**FRIENDS
OF THE
RIVER**

April 29, 2005

Re: Comments on Battle Creek Restoration Project SEIS/REIR

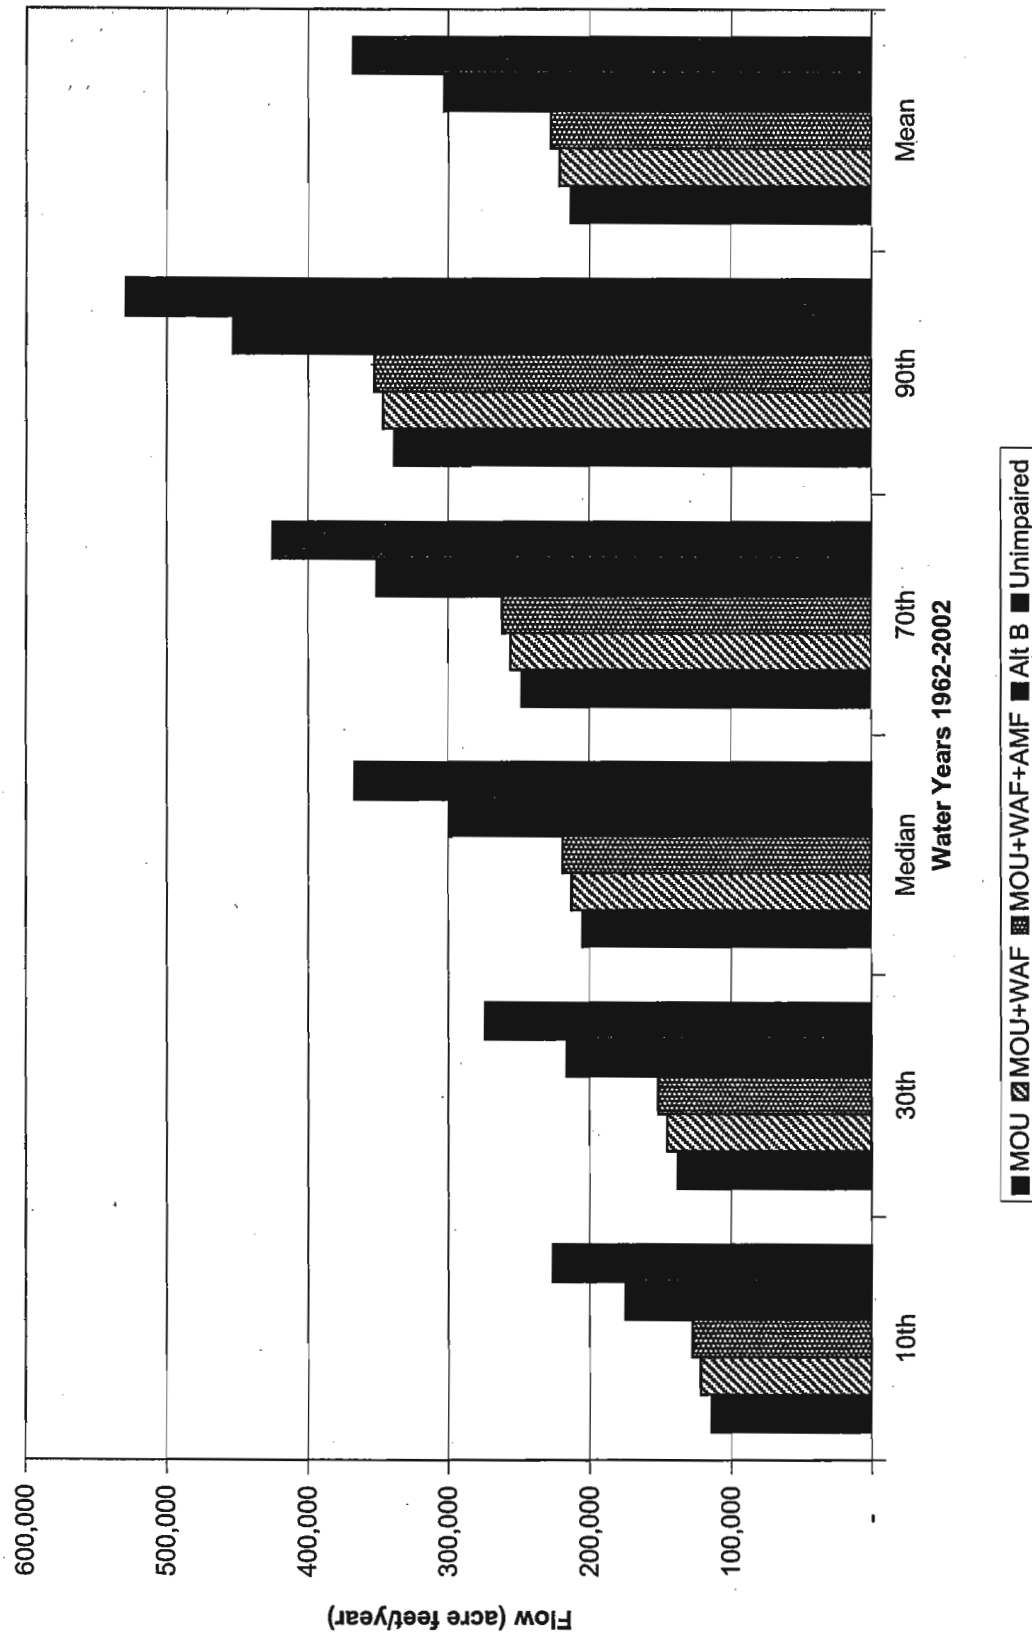
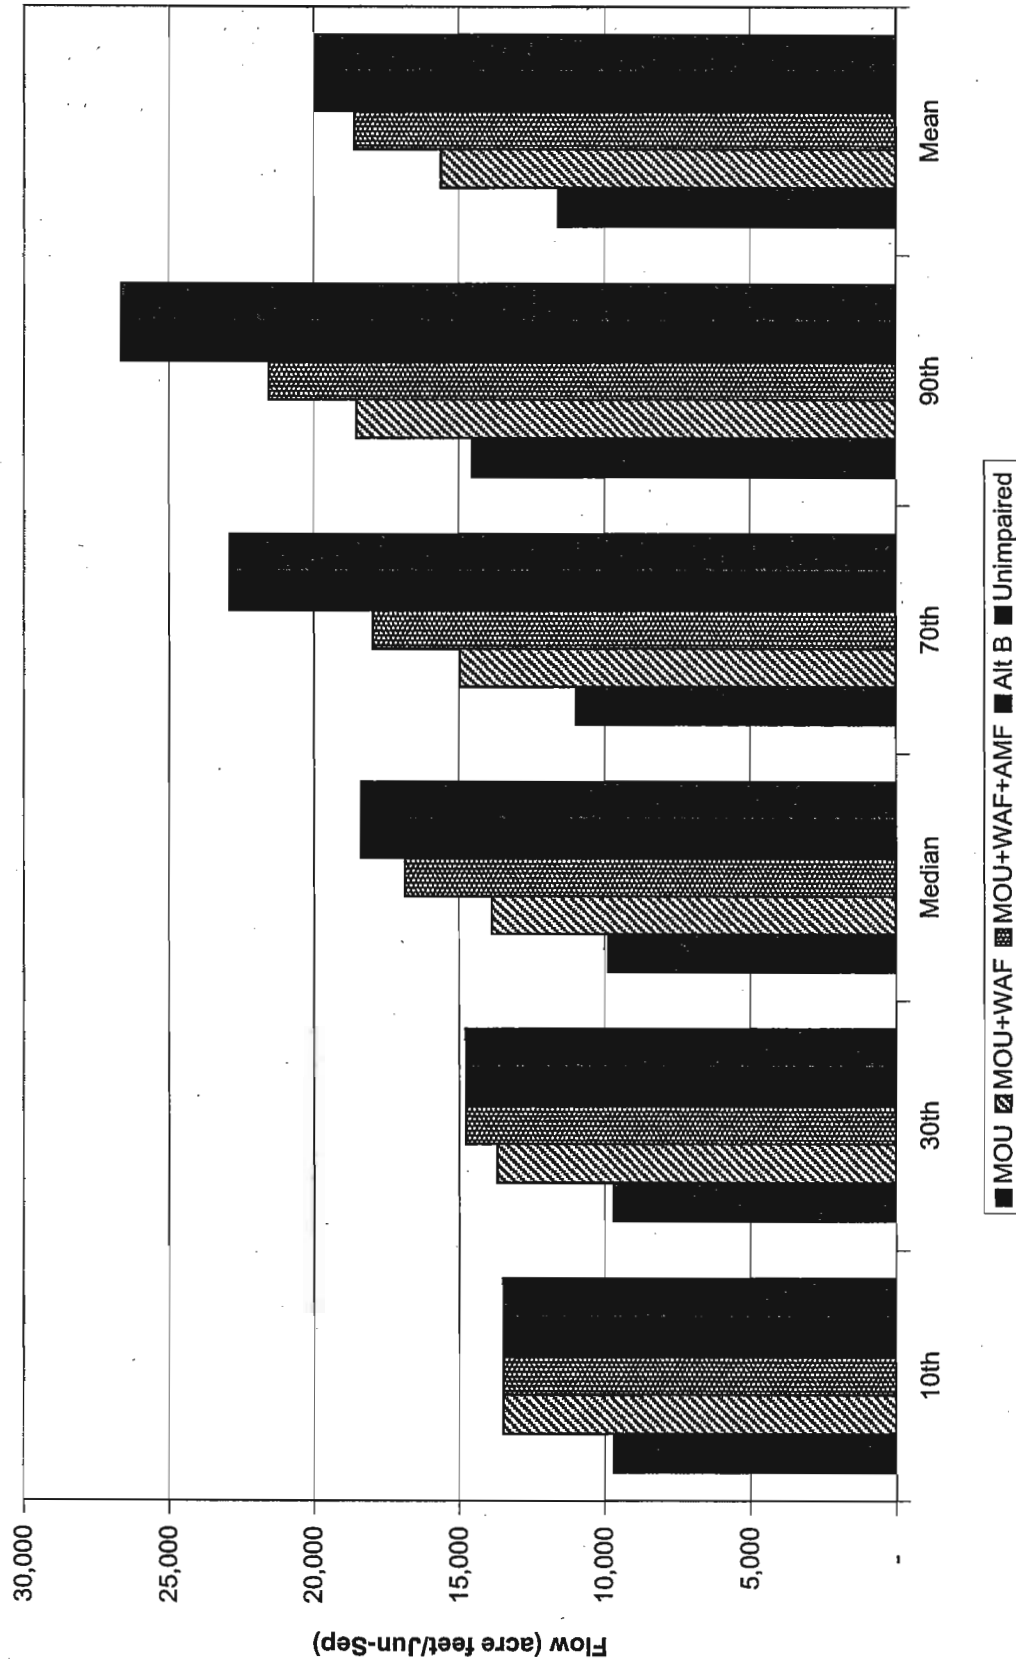
Figures A-1 to A-3 show annual flows expressed in acre feet for three alternatives (MOU, Alt B, Unimpaired) across 5 synthetic year types, plus the mean. For the mainstem and Eagle Canyon, the MOU provides roughly half the flow of Alt B, and a third of the unimpaired flow. MOU flows are relatively higher on the South Fork but are still substantially lower than Alt B flows. Annual acre feet flows are also shown for the MOU alternative plus the two adaptive management flow funds. For illustration purposes, it is

assumed the fund is applied equally across both forks. Figures A-4 to A-6 show summer months only, and assume adaptive management purchases would occur only in June through September, again equally in both forks.

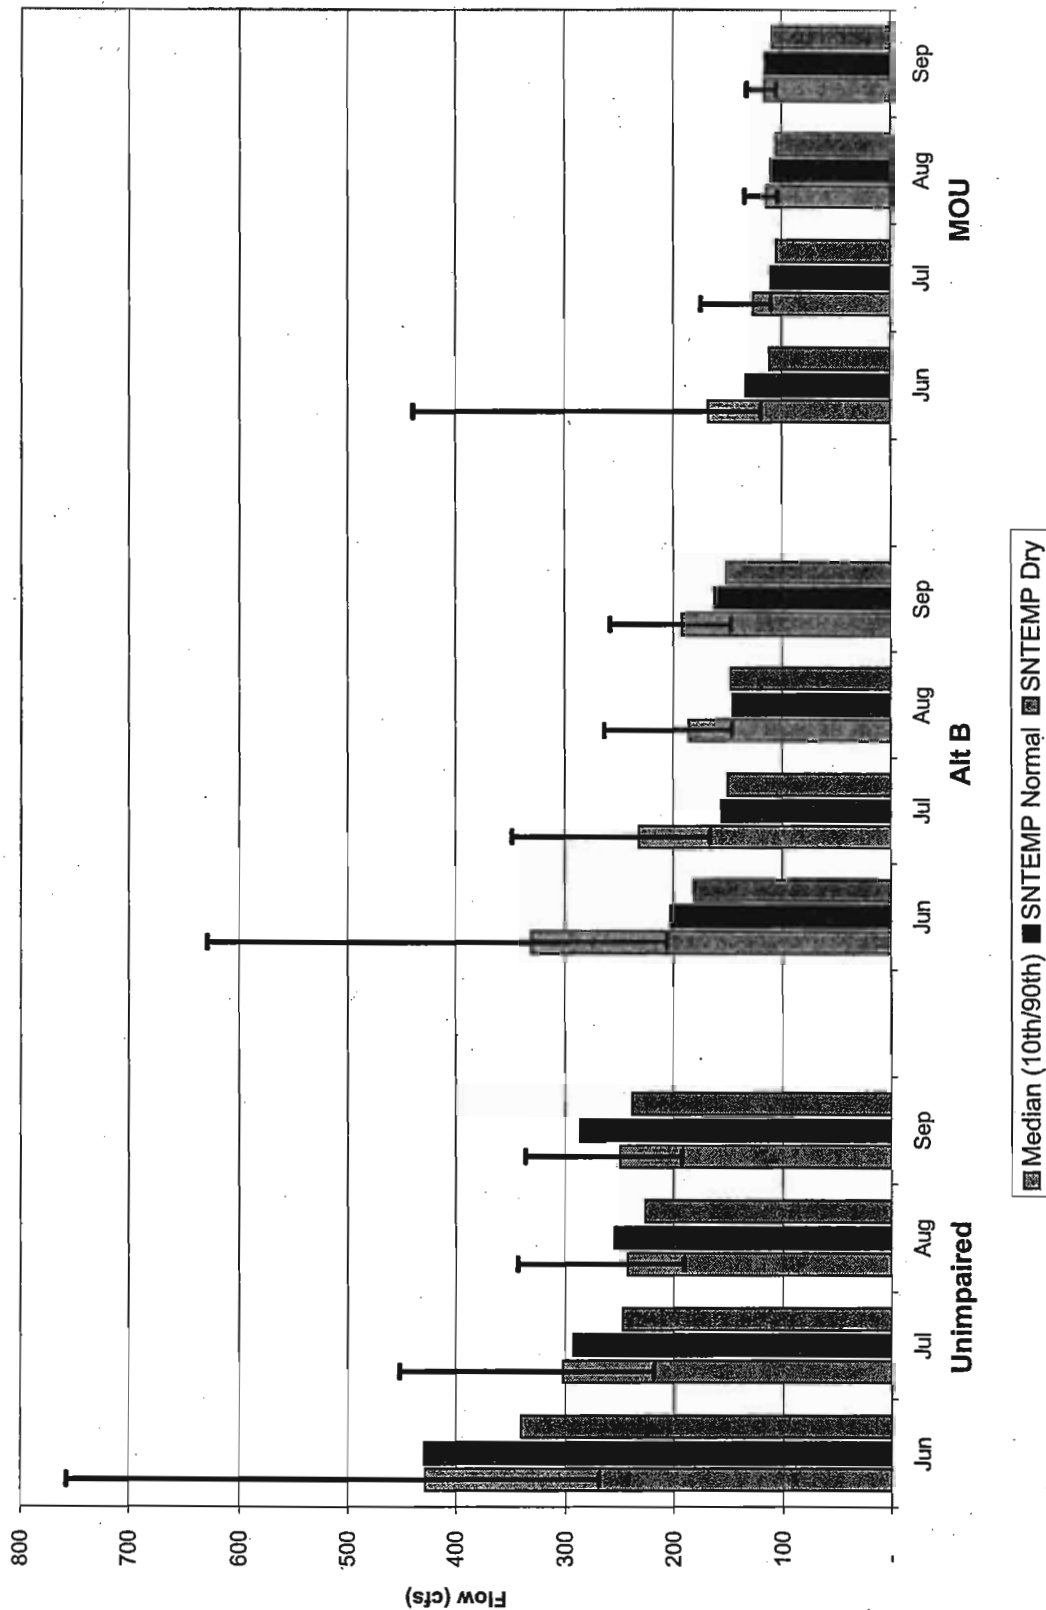
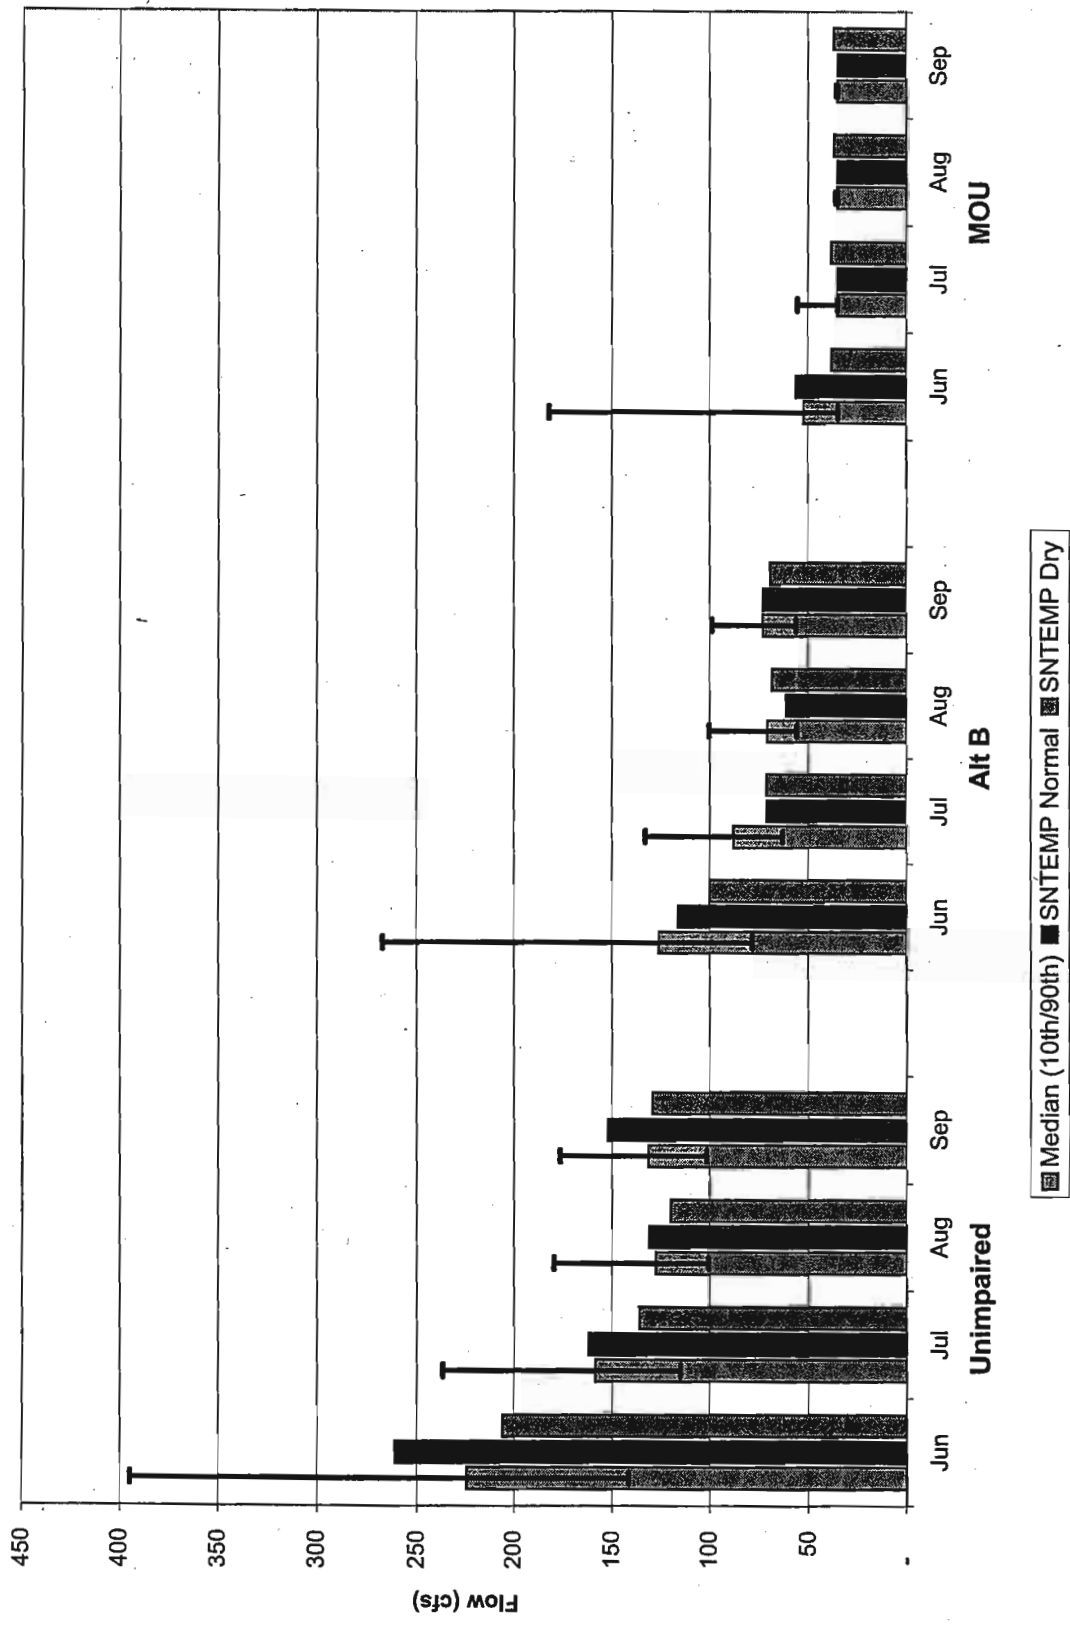
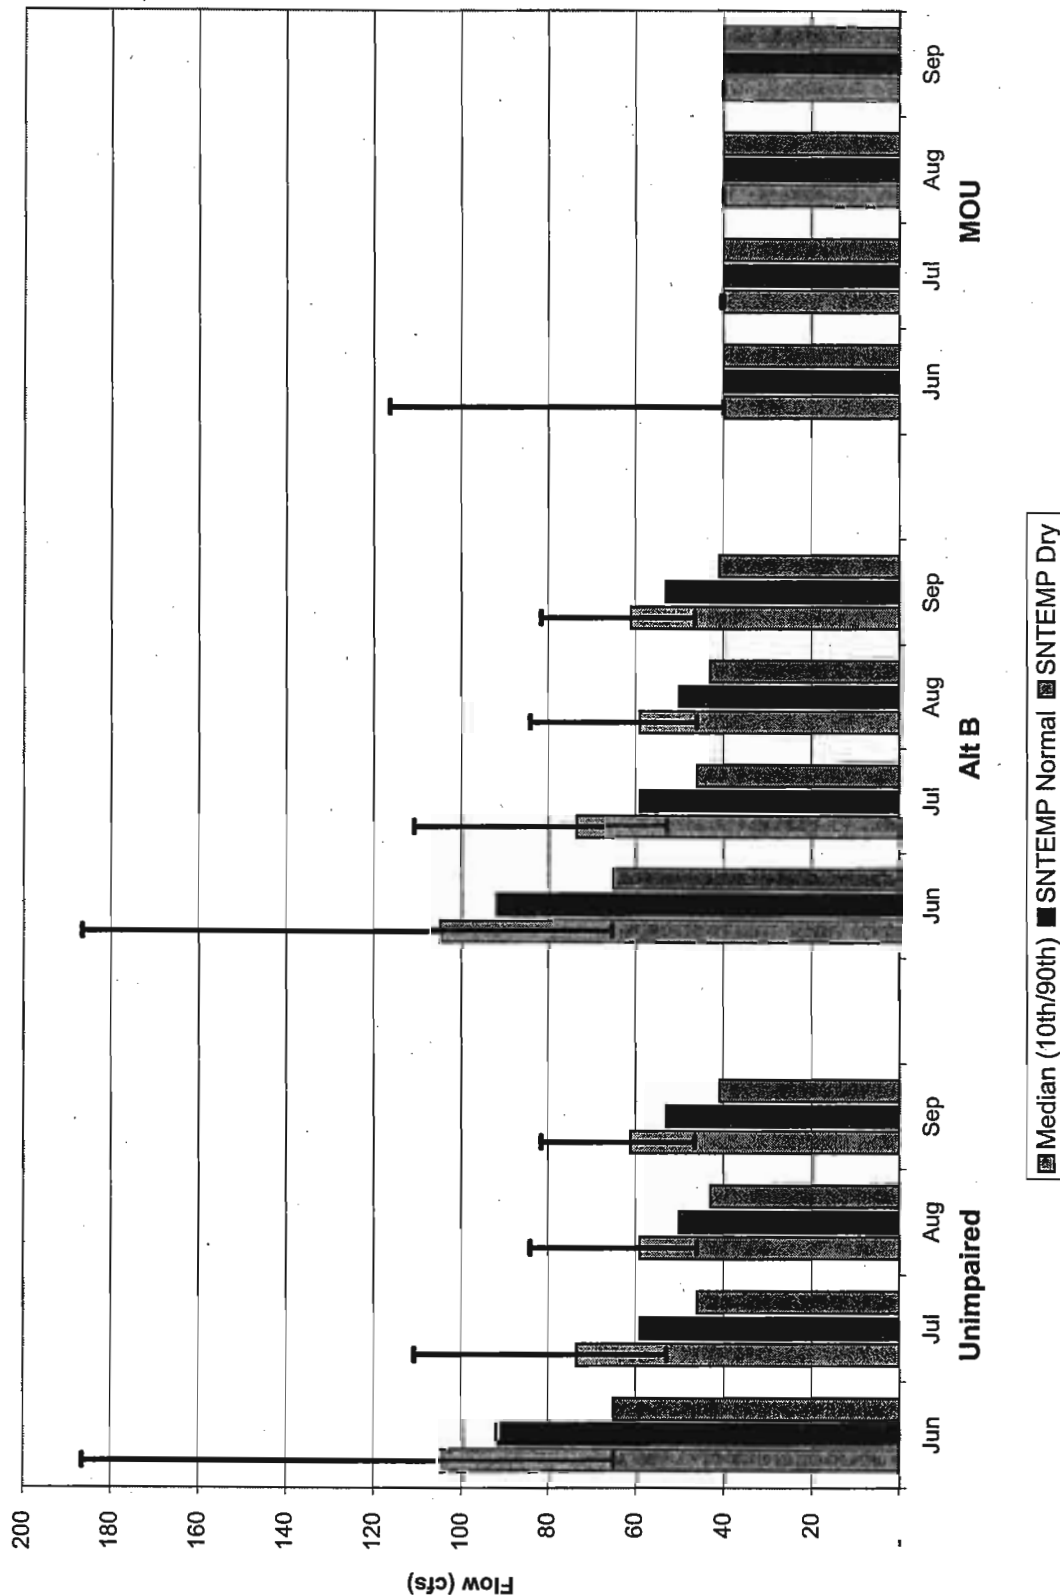
While the flows used in the SNTEMP model for the most part approximate the median flows for the unimpaired and MOU alternatives, they are consistently less than median flows of Alt B. This is especially true on the mainstem (Figure C-1), where SNTEMP normal and dry year flows for Alt B are both less than the 10% synthetic dry year. Further, as discussed above (i.e., hydrology discussion), Alt B maintains considerably more variability from year to year throughout the descending limb of the hydrograph (June and July) and the low flow period (August and September), as shown in Figures S-4 to S-6, and in the 10th/90th braces in Figures C-1 to C-3.

In many year types, Alt B flows approach and equal the volume of flow in the unimpaired alternative modeled by SNTEMP. Interannual variability in the Alt B hydrograph could provide recurring optimal temperatures in the forks and mainstem of Battle Creek. Other than June, the MOU alternative does not share this characteristic. A careful comparison of

Figures C-1 to C-3 to SNTEMP suggests that, corrected for flow, SNTEMP would show substantial temperature benefits for Alt B relative to the MOU.

Conservative flow-based temperature correction estimate of 1°F for Alt B mainstem, June is based upon Figure C-1, which shows SNTemp Alt B normal flow is at the 10% Navigant flow level. Navigant median Alt B June flow is closer to SNTemp unimpaired June, which is 4-5°F cooler in Figure T-1. However, the additional Navigant Alt B flow volume is composed of both NF and SF water, whereas the flow in excess of SNTemp Alt B in unimpaired SNTemp is entirely NF water (from Volta), and presumably colder.
